# NEI 17-06 Review

Modernization Plan #3-  
Commercial Grade  
Dedication

November 6, 2019

# NRC Comments on NEI 17-06 Rev B

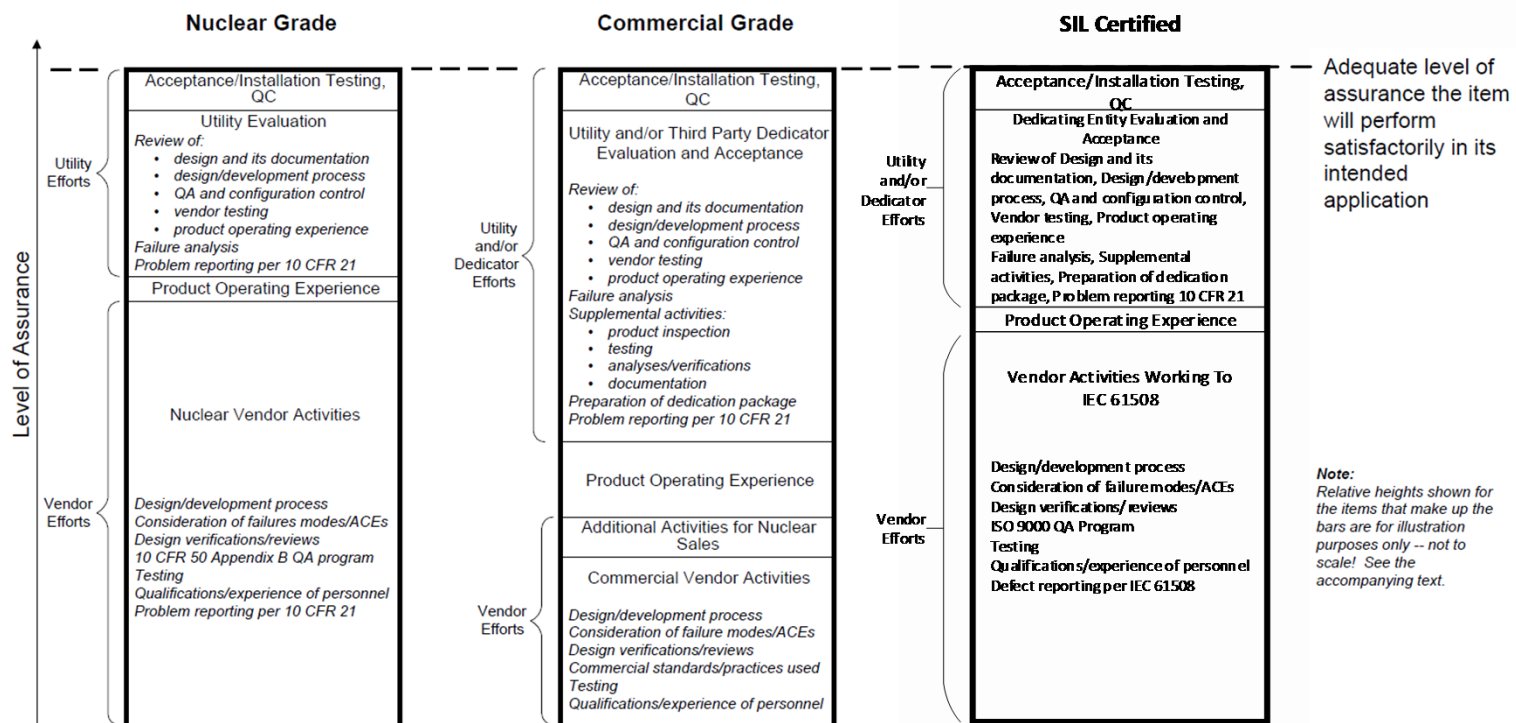
Figure 4.2 may be misleading. The two blocks “Review of SIL Certification” may not be equivalent to the corresponding blocks on the left because CBs certification may not consider nuclear specific requirements such as radiation resistance.

*Response- The remaining blocks on the left labeled as “Qualification Testing...” and “Implement the Method 1...” are where the nuclear specific requirements such as radiation resistance are addresses.*
